## **PLANNING COMMISSION MEETING AGENDA REGULAR MEETING**

**October 22, 2024**

SUBJECT: PUBLIC HEARING – SPECIAL USE APPROVAL AND PRELIMINARY SITE PLAN REVIEW (SU JPLN2024-0021) – Proposed Residence Inn Hotel, South side of Butterfield, East of Coolidge (2125 & 2155 Butterfield), Section 29, Currently zoned BB (Big Beaver) Zoning District.

## Special Use and Preliminary Site Plan For City of Troy, Michigan

## SITE LAYOUT PLAN

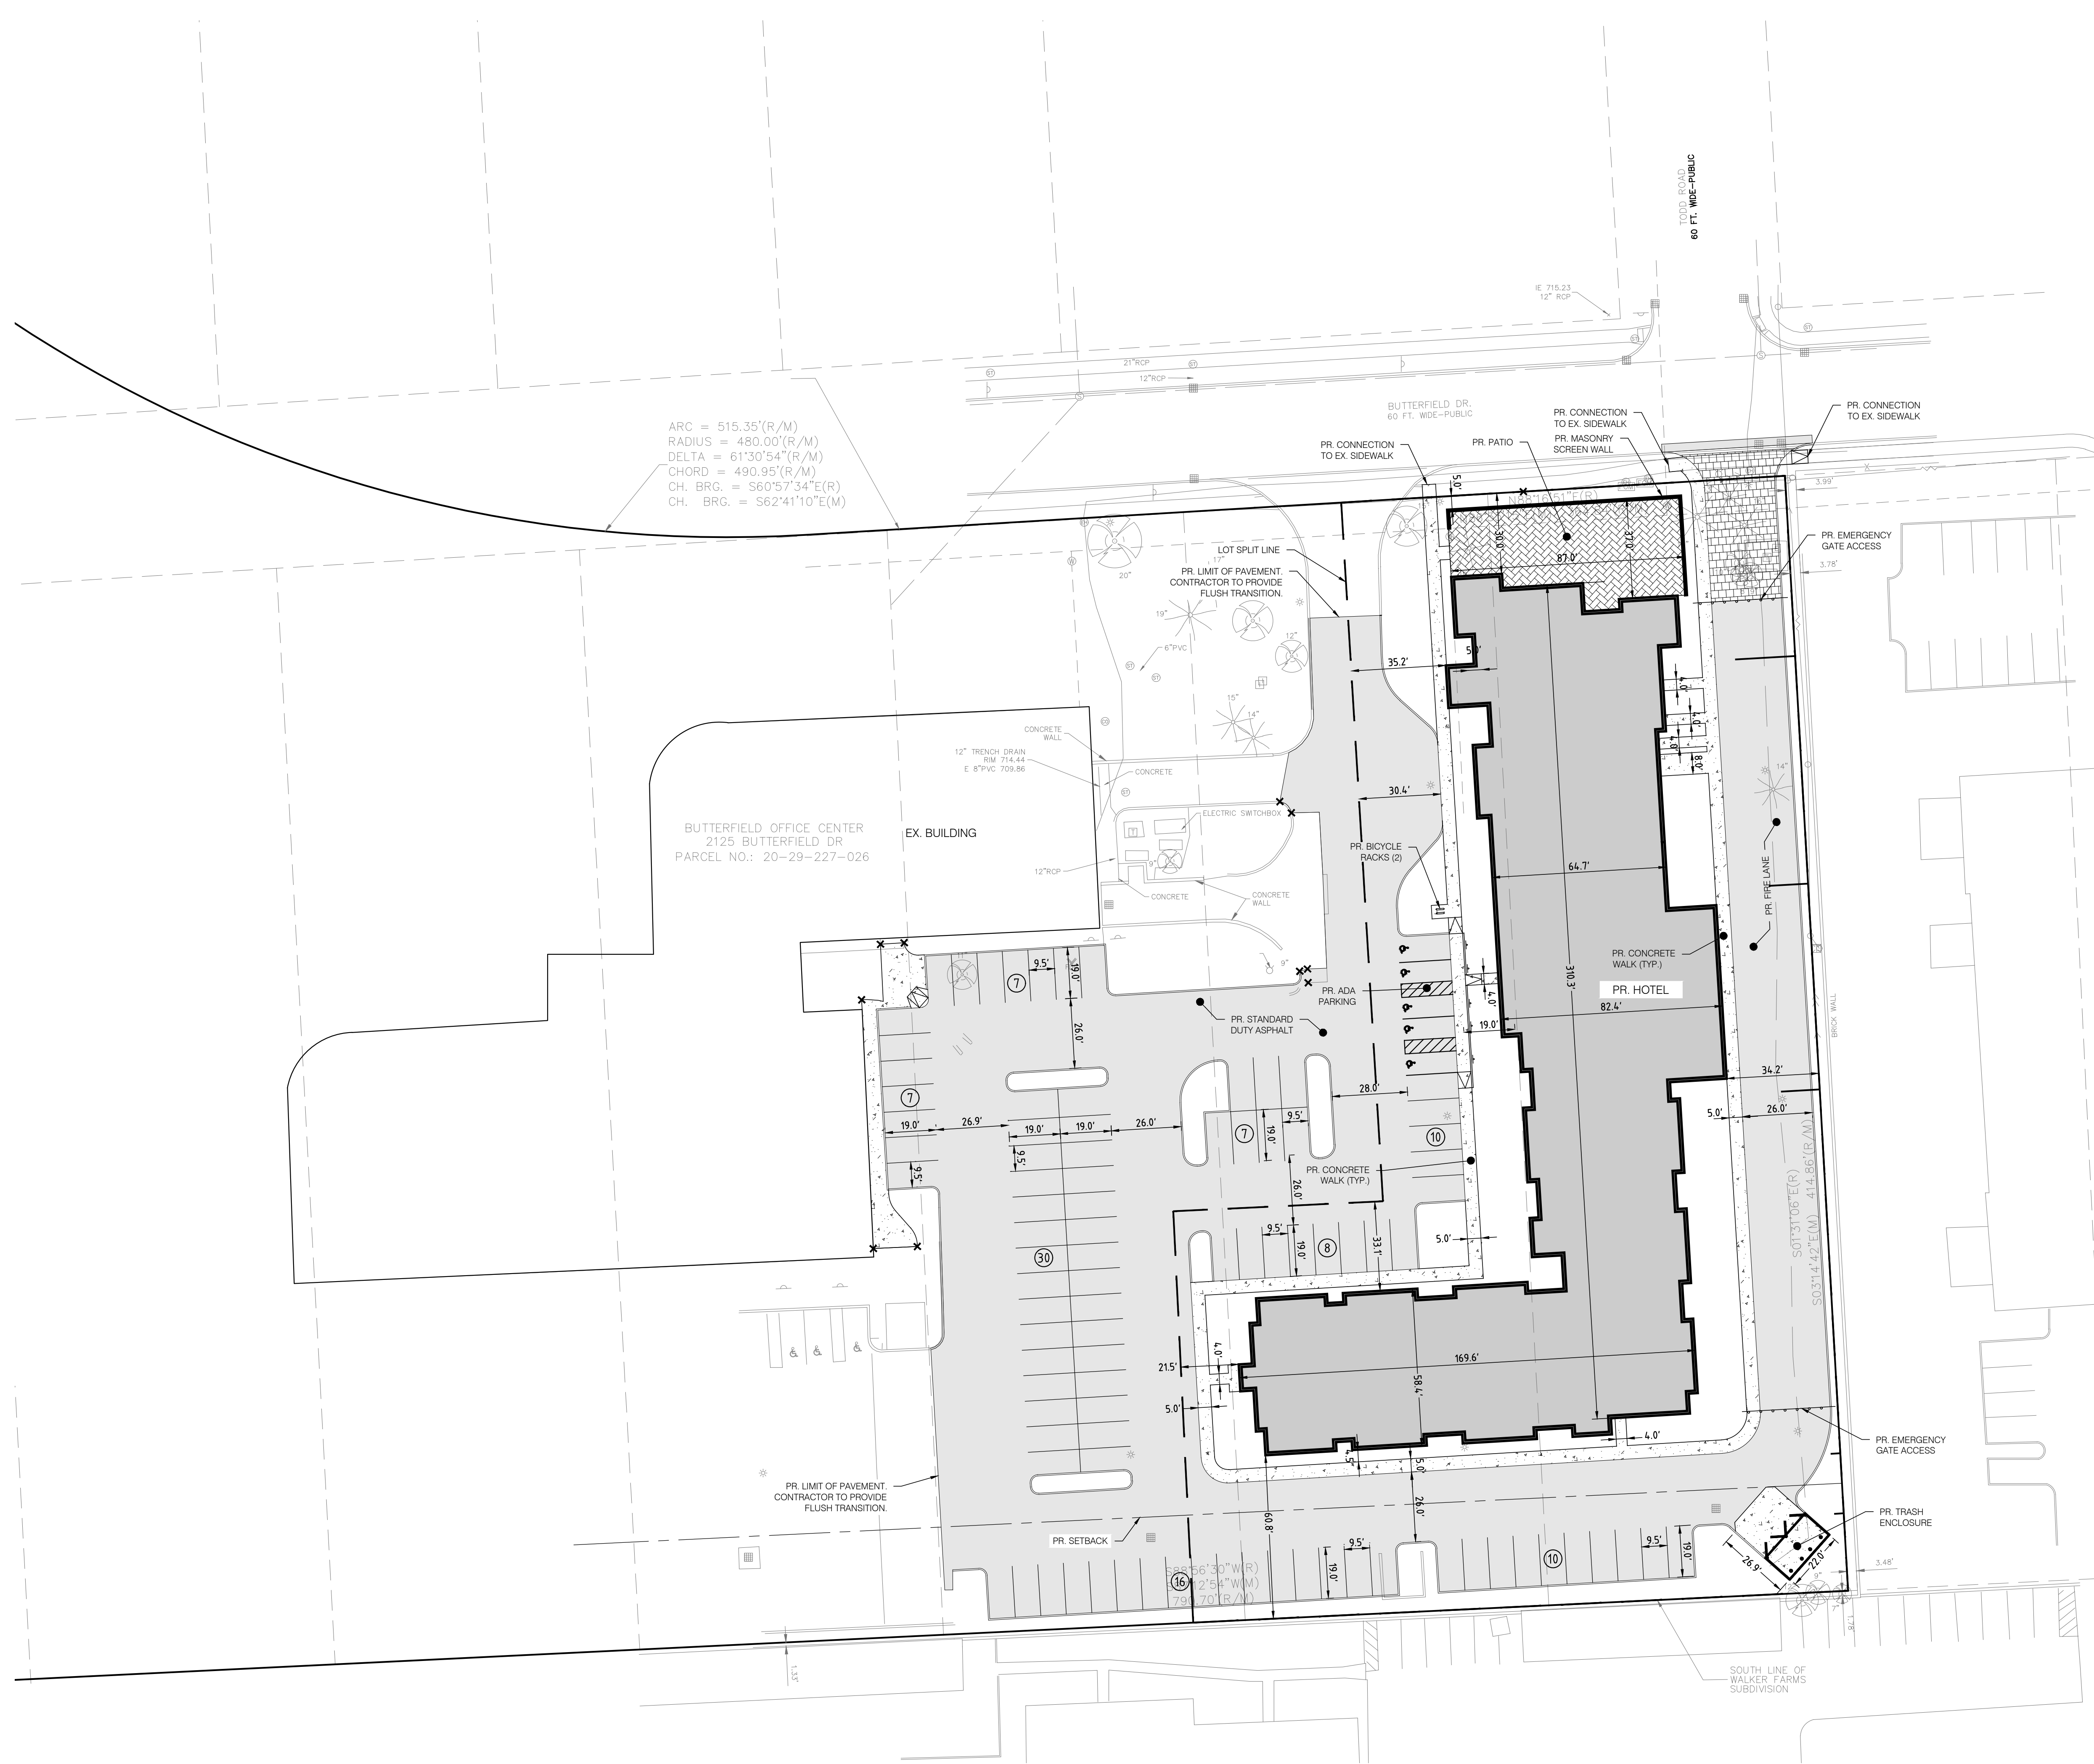
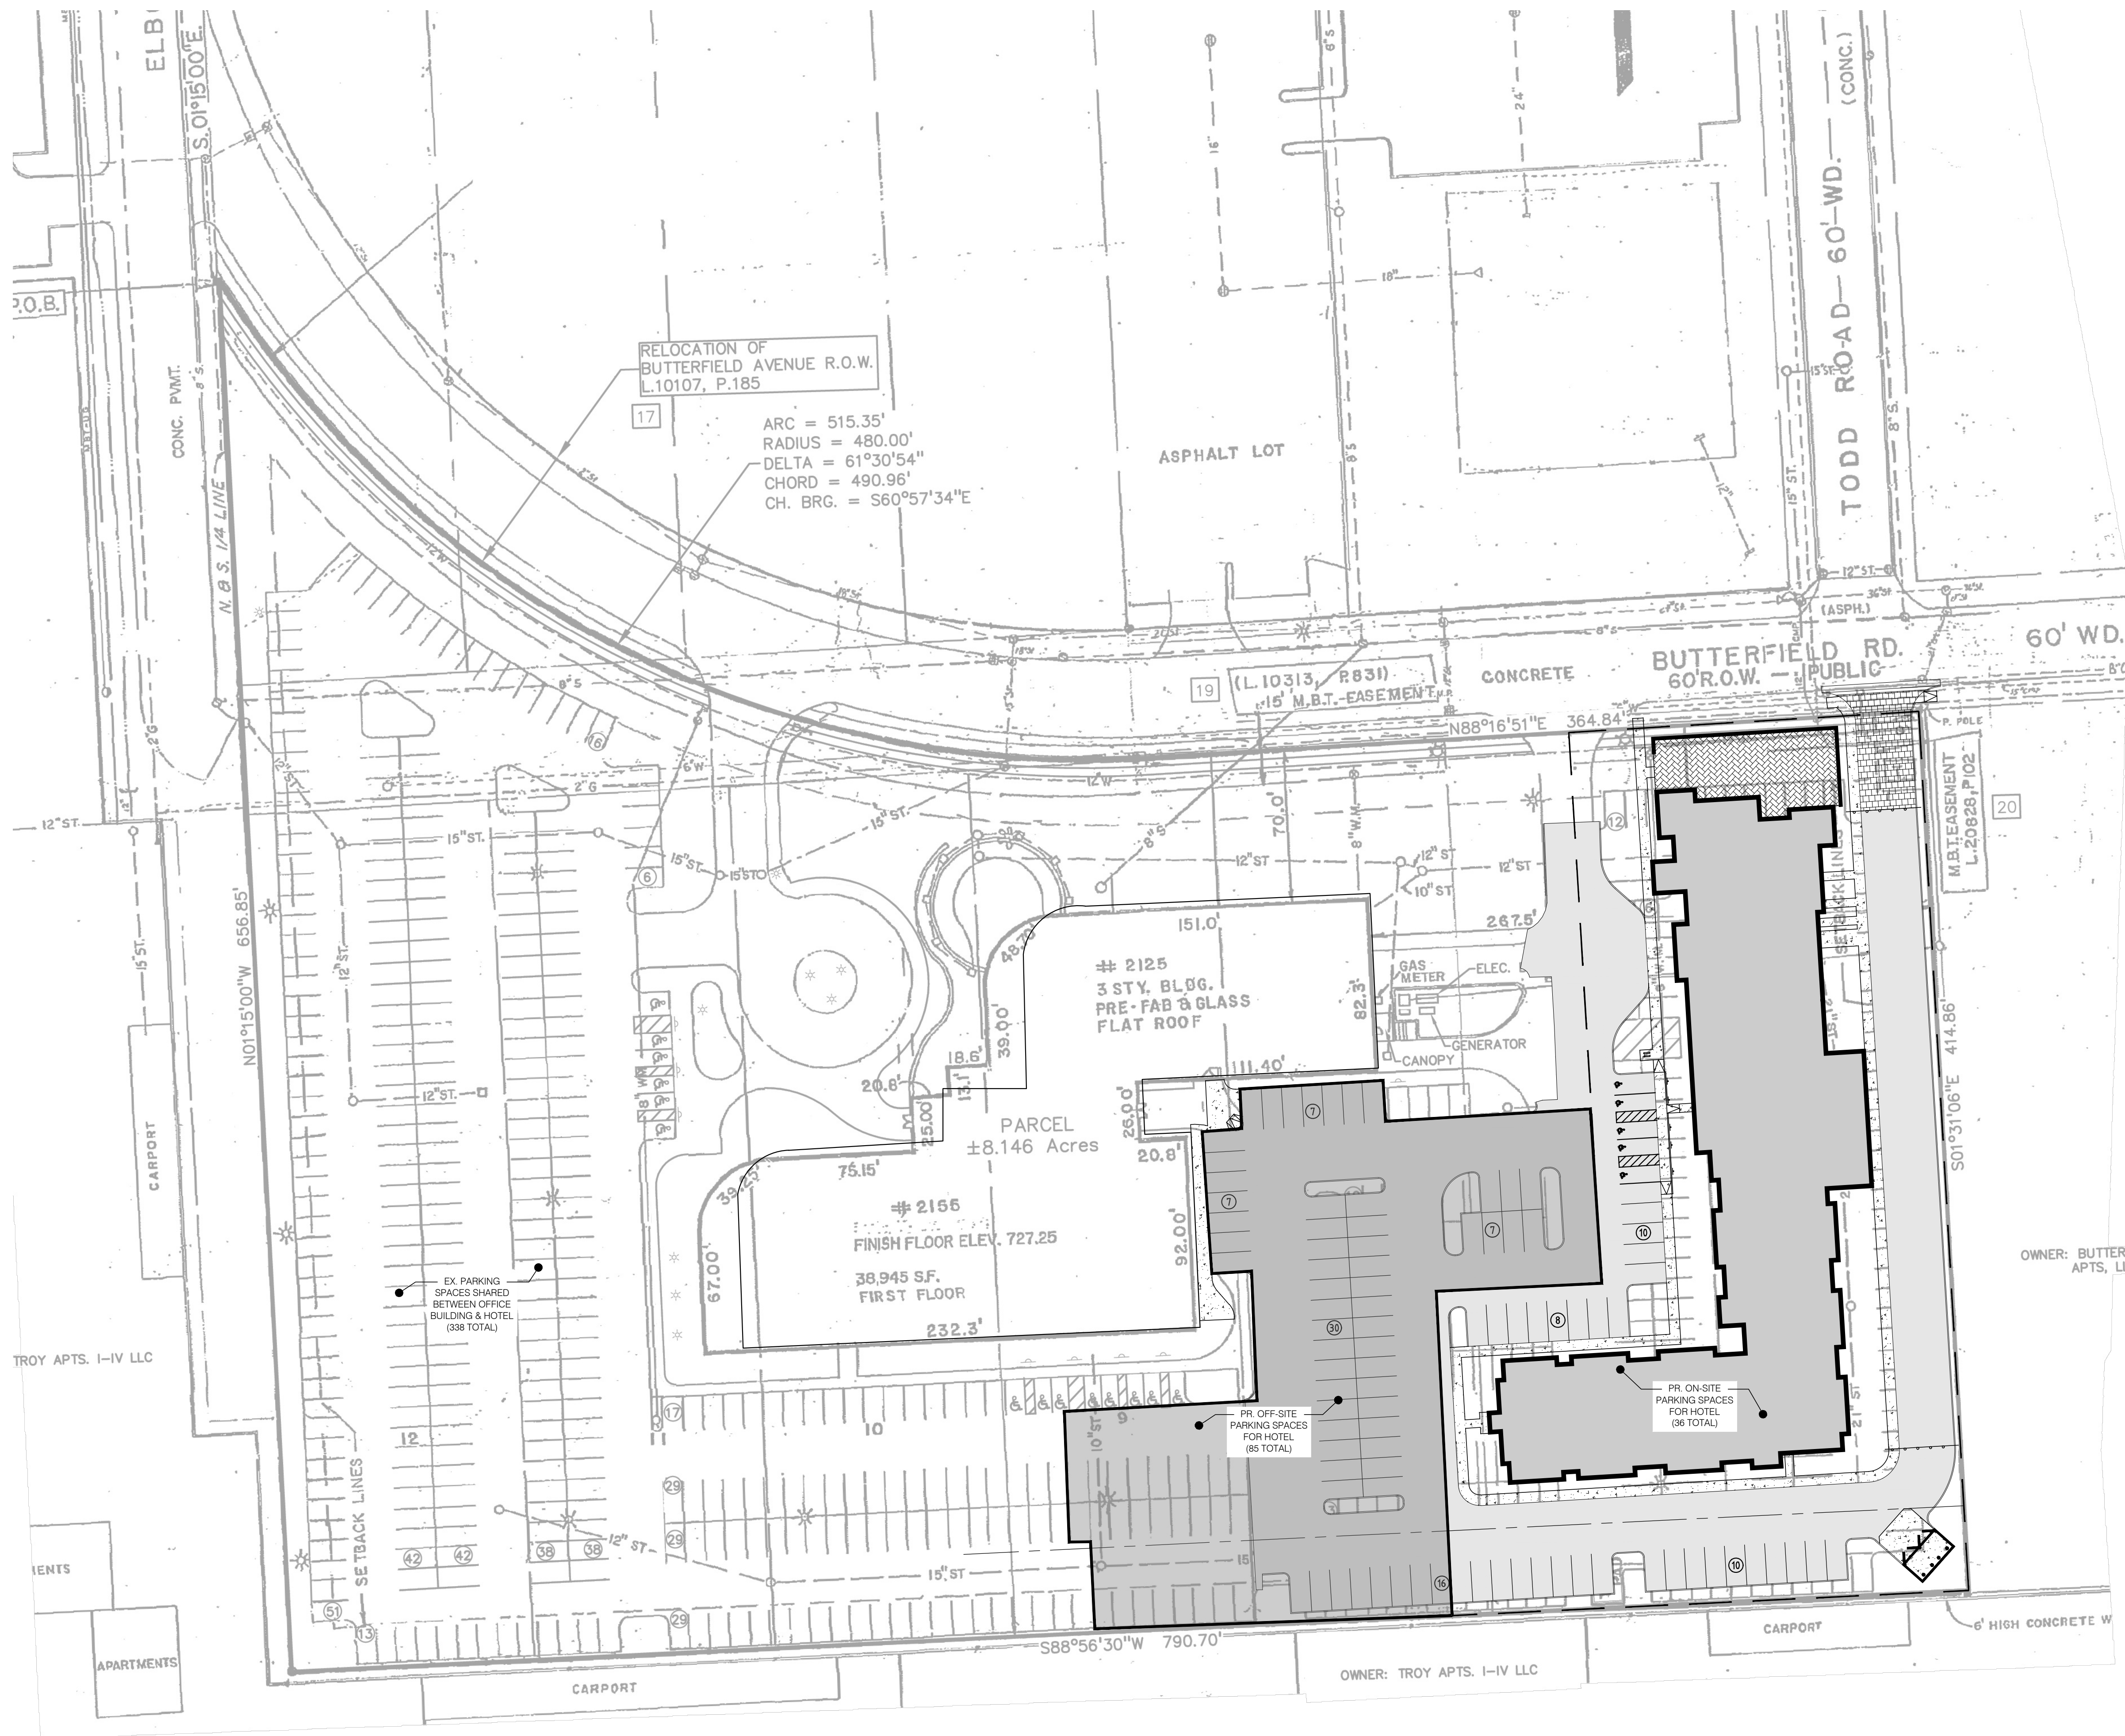
The proposed front setback does not conform with the 10-foot build to line requirement; although, the Planning Commission may adjust the required building line to a maximum of 30-feet beyond the property line for projects incorporating a permanent space for an outdoor café, public space, or a cross-access drive with an adjacent parcel.

**Items to be Addressed:** 1). Planning Commission consideration of 30-foot front setback with outdoor seating.

**Items to be Addressed:** 1). Bring site into compliance with parking standards or seek parking deviation through the Planning Commission.
